# UNITED STATES PATENT AND TRADEMARK OFFICE

APPLICATION NO.	FILING DATE	FIRST NAMED INVENTOR	ATTORNEY DOCKET NO.	CONFIRMATION NO.
10/760,243	01/21/2004	Kia Silverbrook	MPA12US	1580

<b>Office Action Summary</b>	Application No. 10/760,243	Applicant(s) SILVERBROOK ET AL.	
	Examiner Laura E. Martin	Art Unit 2853

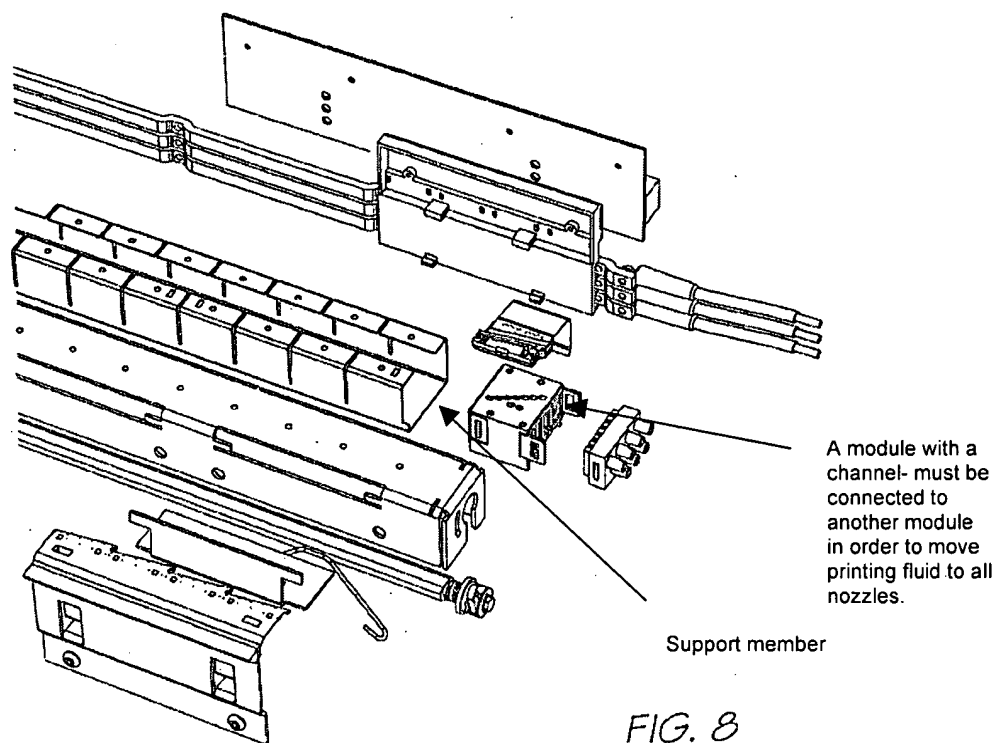
As per claim 1: each support member has at least one longitudinally extending channel for carrying the printing fluid for the printhead integrated circuits which is configured to communicate said printing fluid with the channel of the adjacent support member (see figure 8 below).
